ADDENDUM NO. 1

**JACKSON ELEMENTARY SCHOOL RENOVATIONS
Valparaiso, IN 46304**

This Addendum consists of page ADD 1-1 and attached Addendum No. 1 from Gibraltar Design dated November 9, 2022 and consisting of 4 pages and 29 drawings.

Addendum One (AD.01) to the drawings and specifications prepared by Gibraltar Design for **Jackson Elementary School Renovations** for Duneland School Corporation, Chesterton, Indiana.

A-720

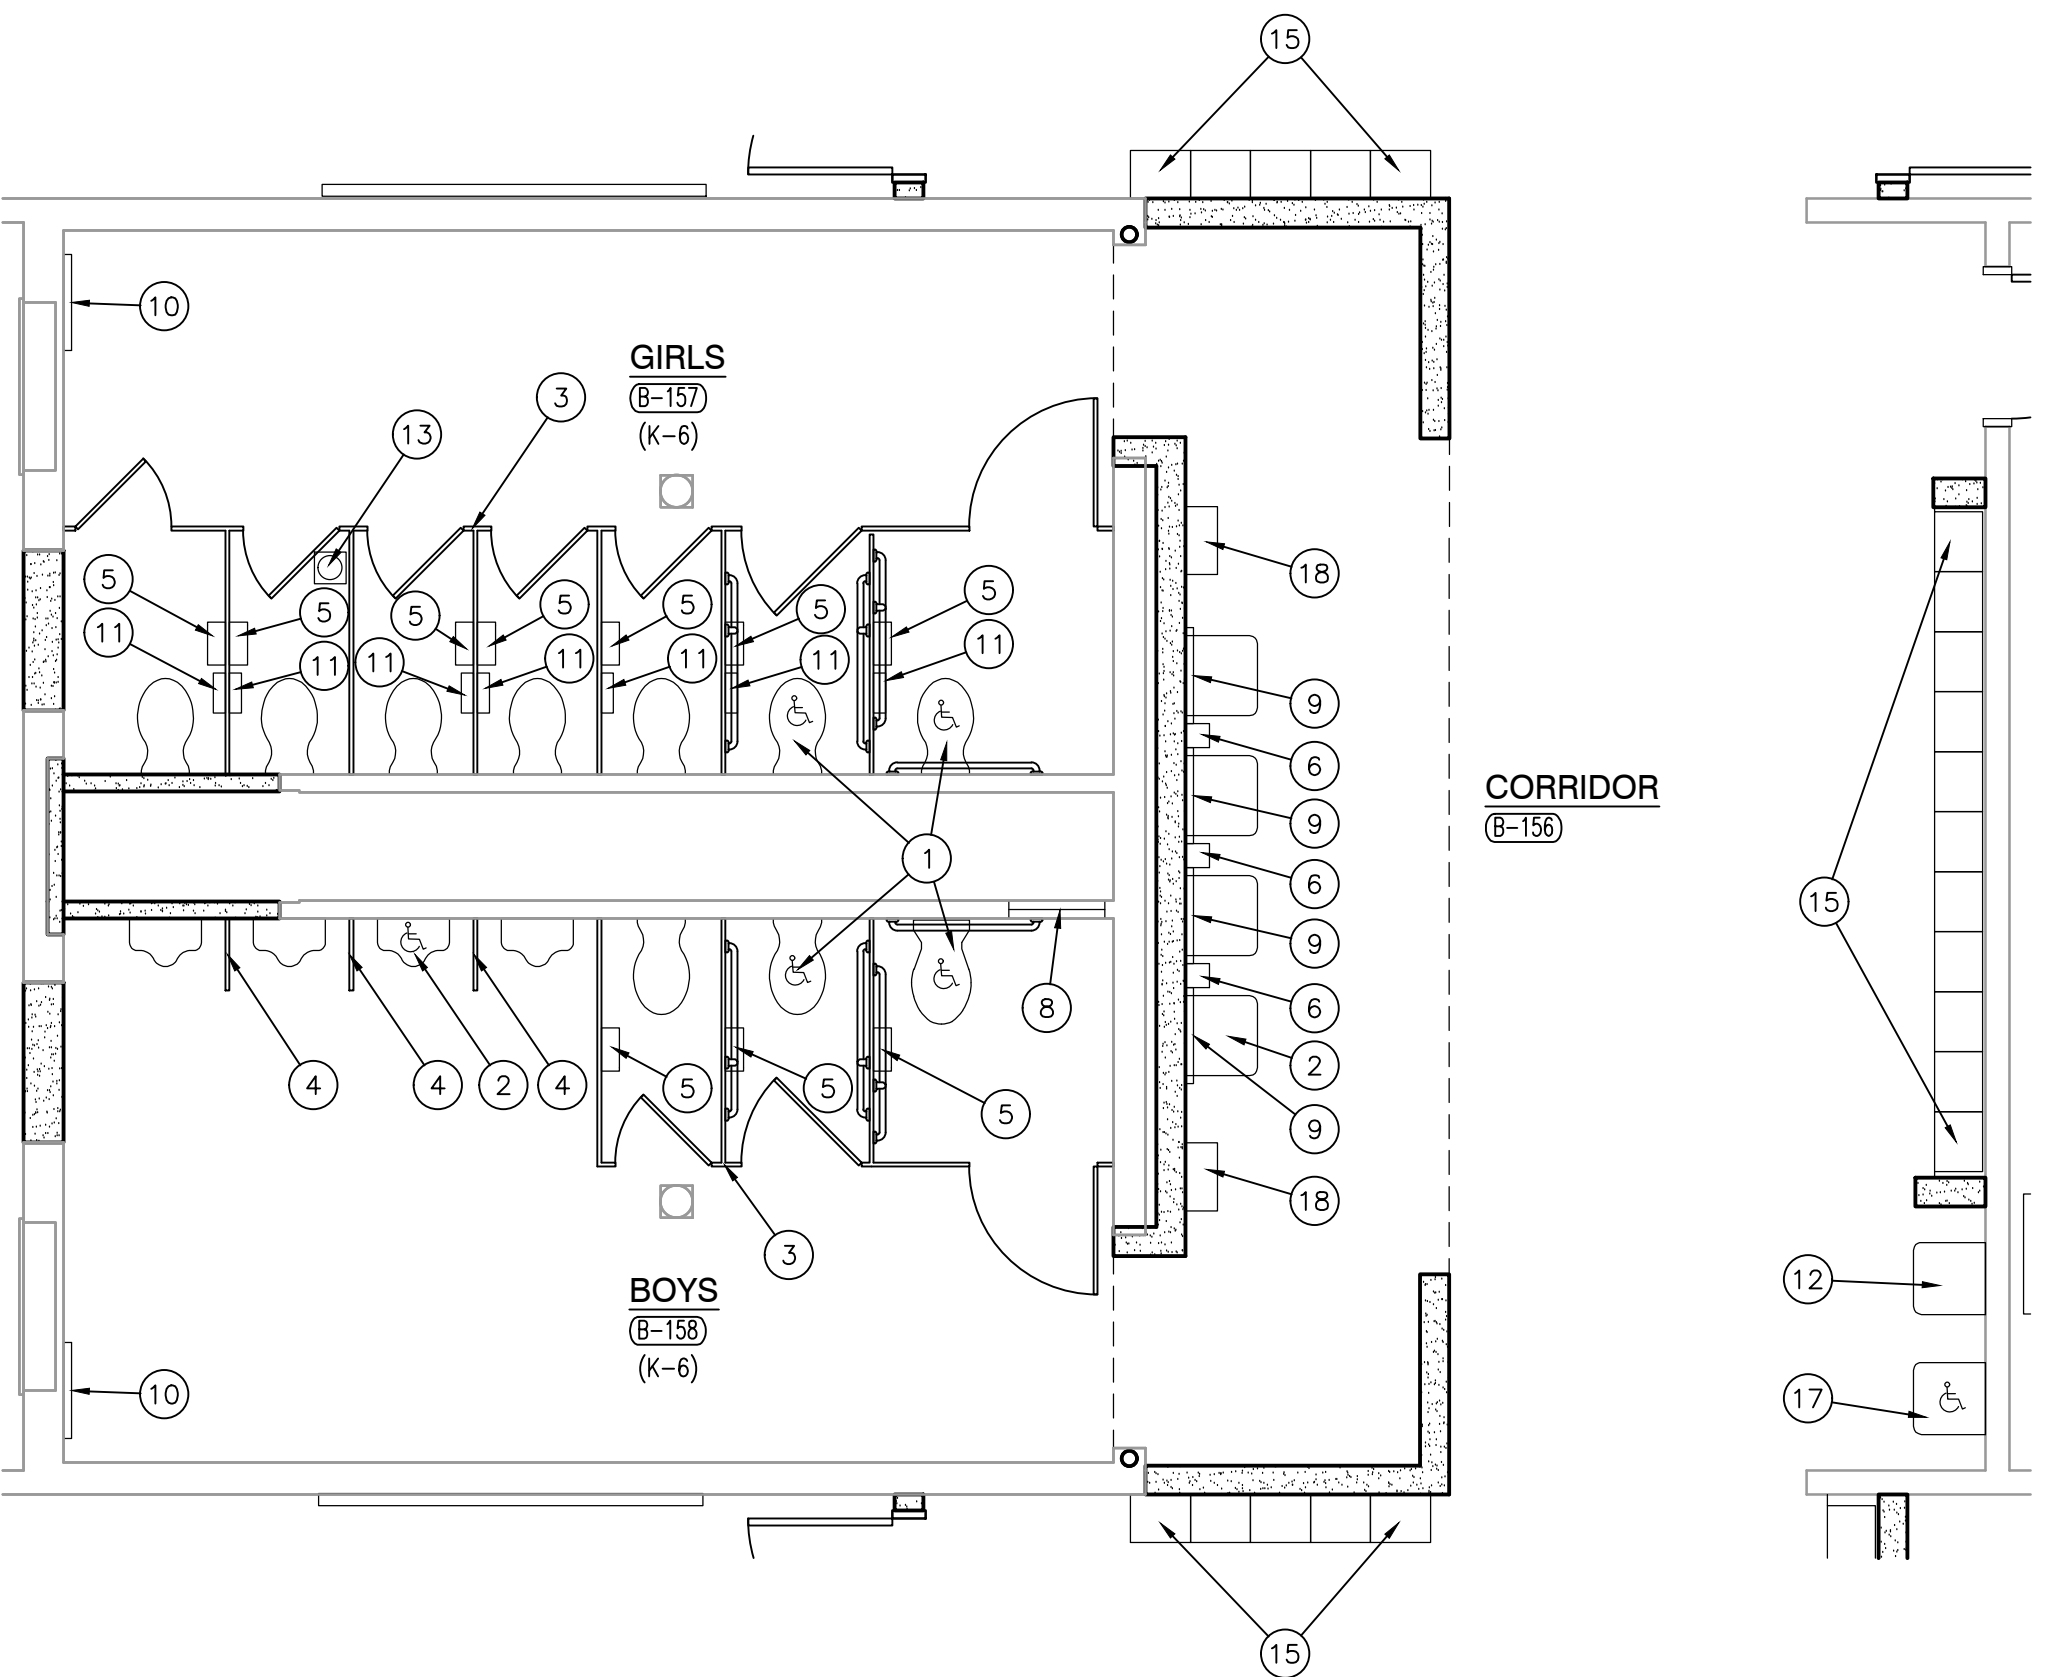
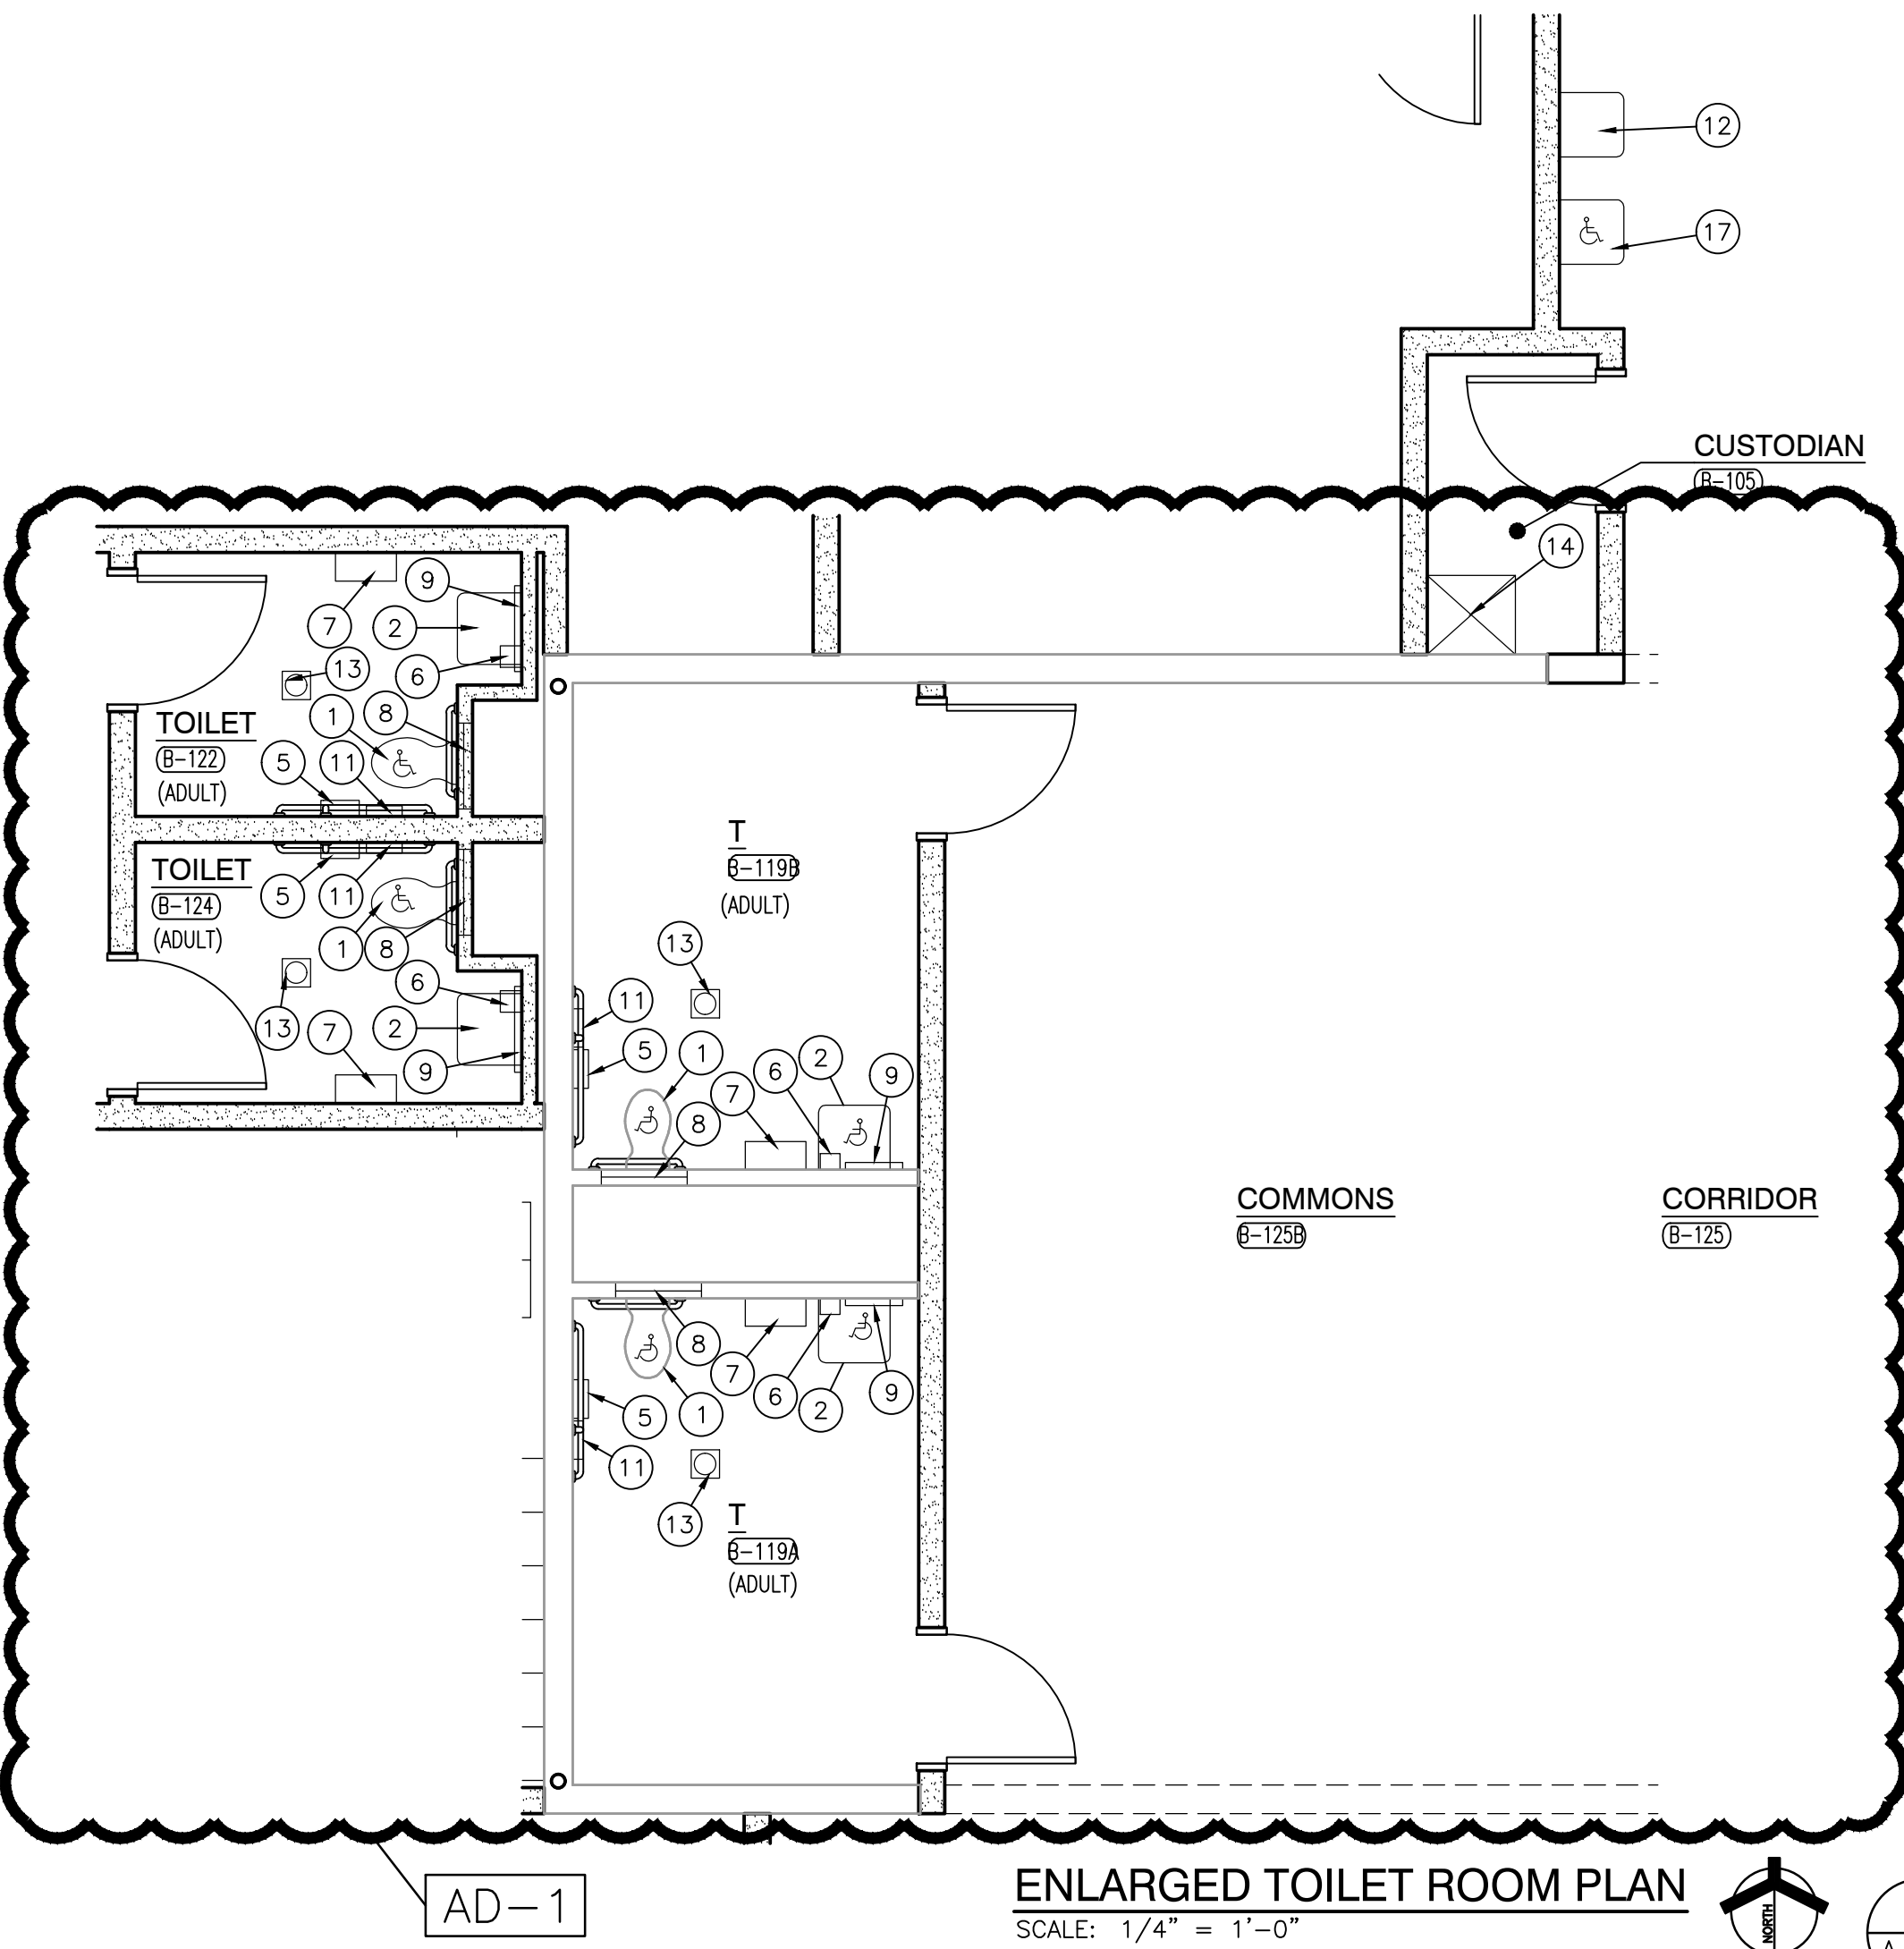
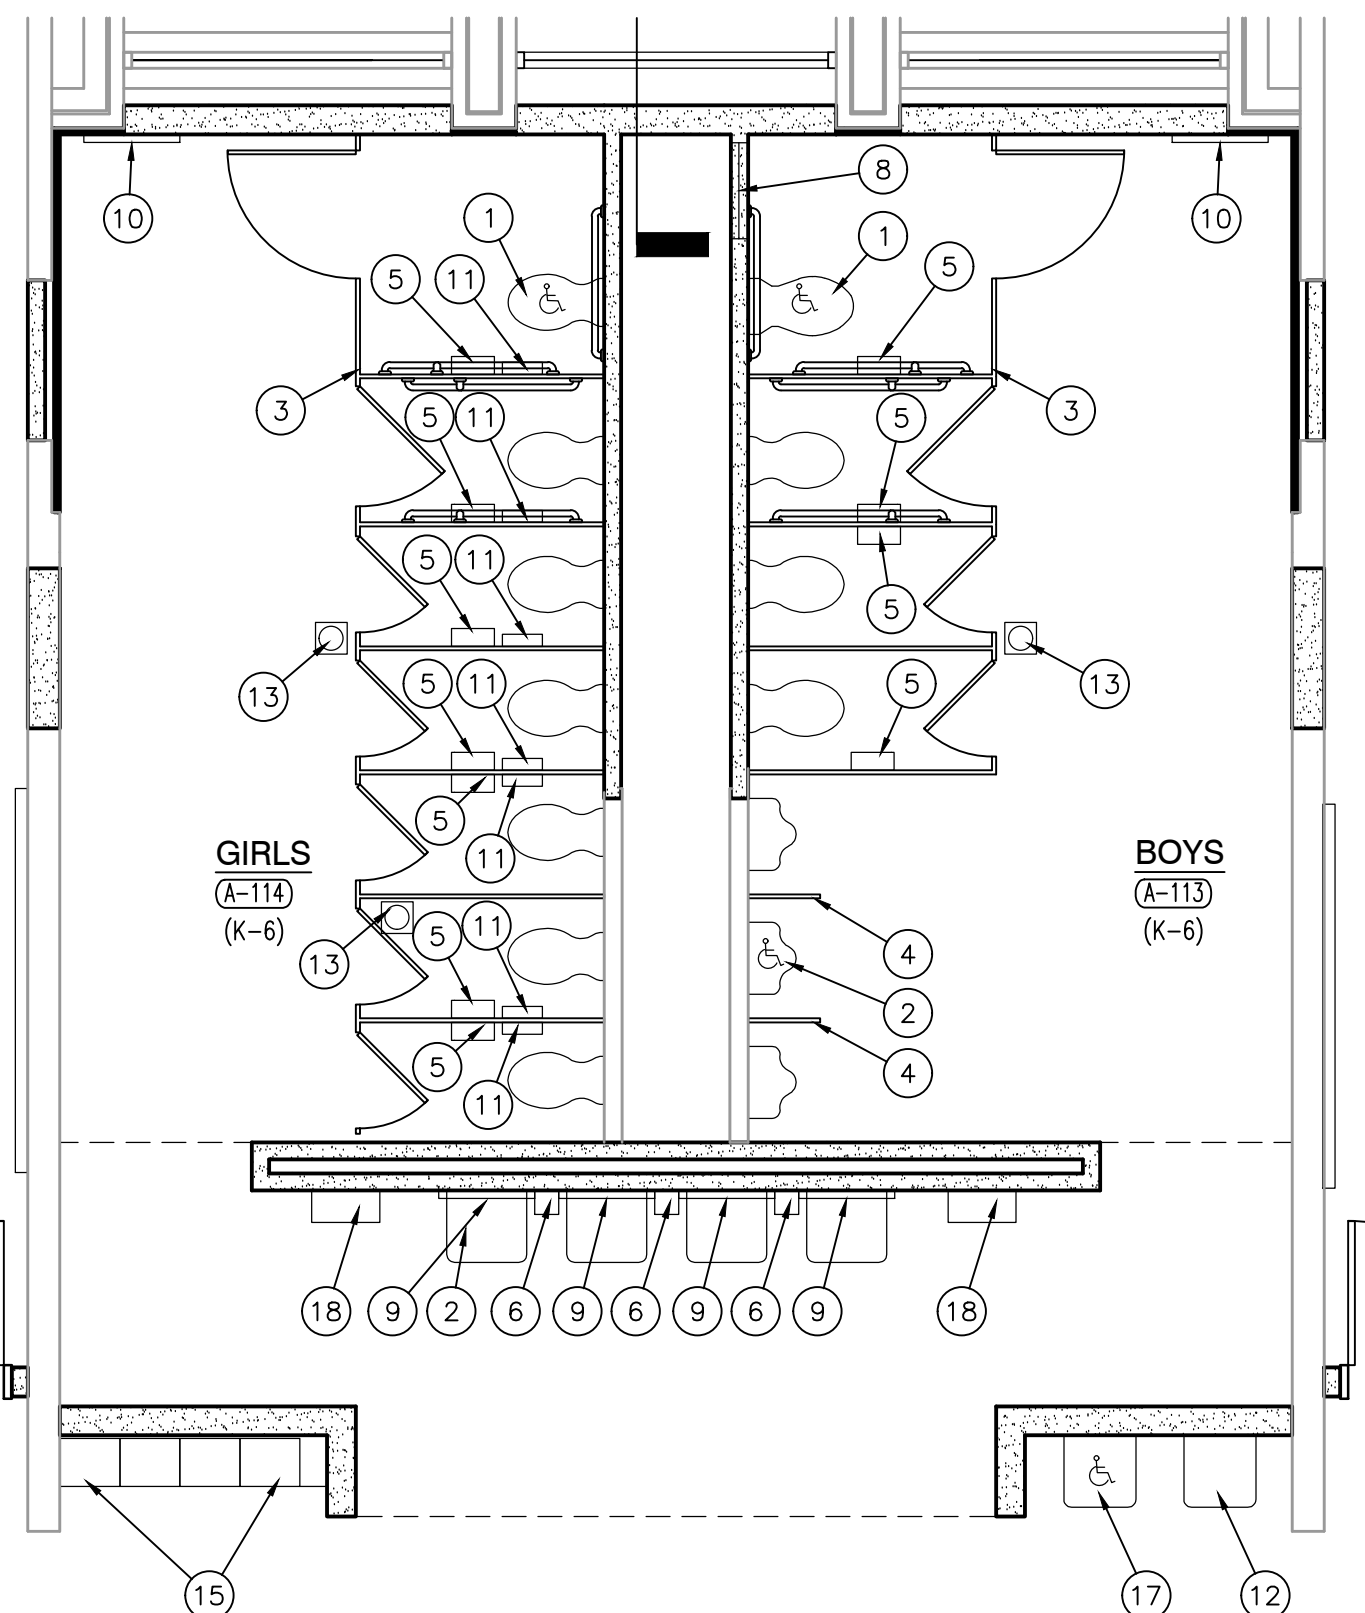
**7. Sheet A-720**

A. Refer to revised full size drawing, included in this Addendum, for the following revisions:

1. Updated Enlarged Restroom detail 3/A-720 to include Toilet B-119A, and Toilet B-119B.
